MC Shell NBI port cut
 dimension change on
 part # s17e172-017

The modular coil shell opening and NBI port were reshaped to eliminate port interference with modular coils.

SIMPLFD REP: MC_NBI_PORT

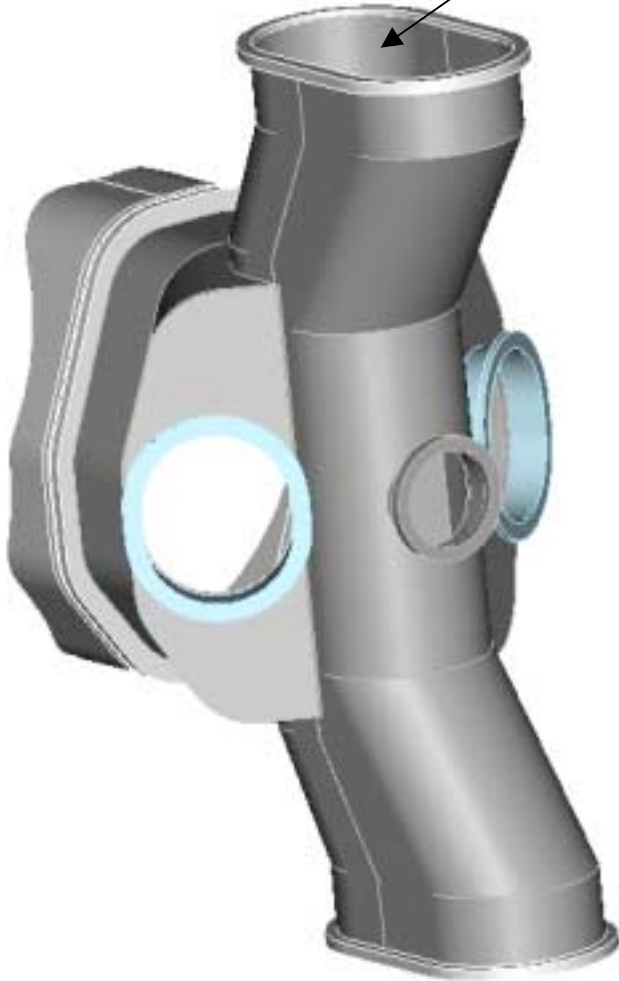
Port geometry was configured to provide clearance among port, NBI beam and modular coil.

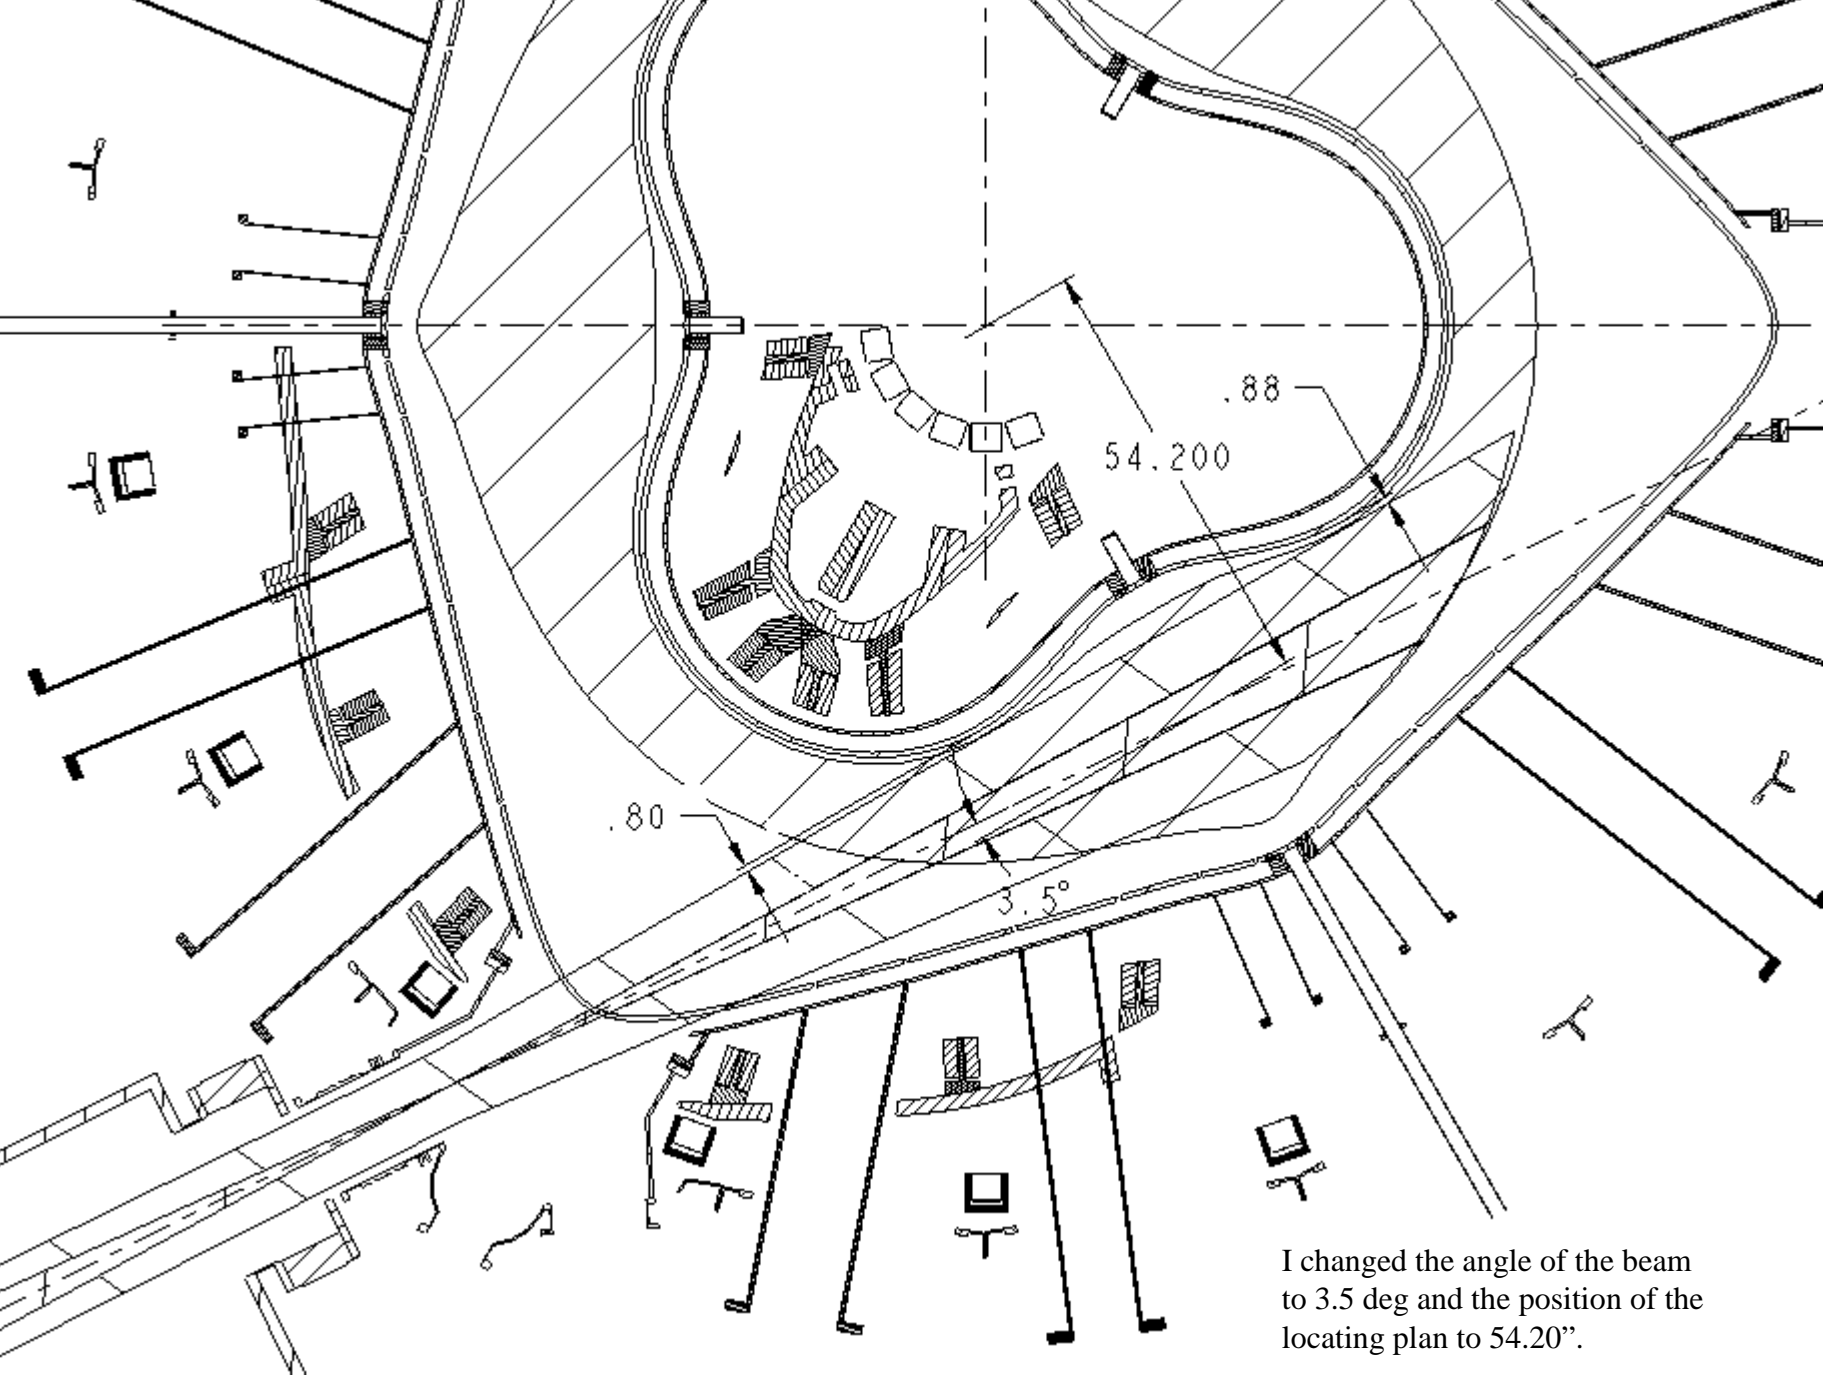
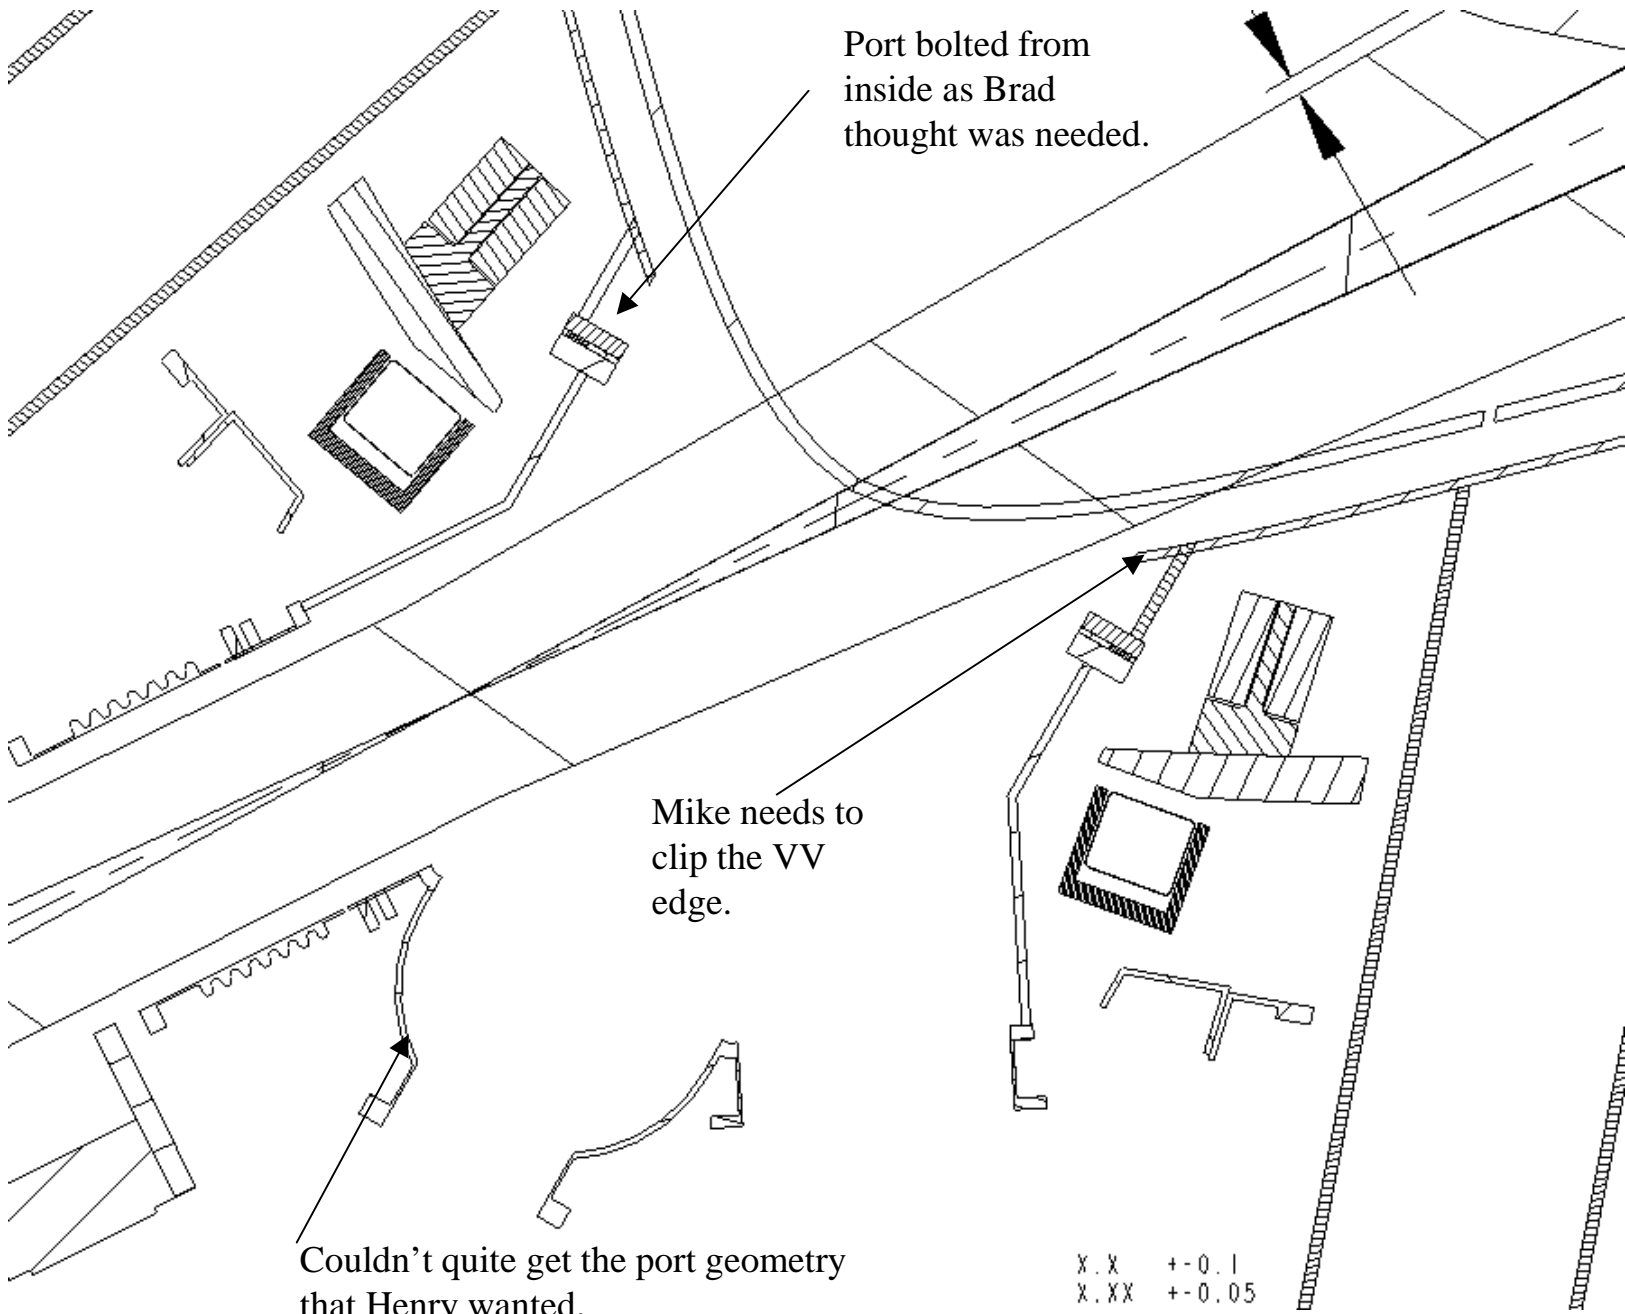
I changed the angle of the beam to 3.5 deg and the position of the locating plan to 54.20".

Port bolted from inside as Brad thought was needed.

Mike needs to clip the VV edge.

Couldn't quite get the port geometry that Henry wanted.
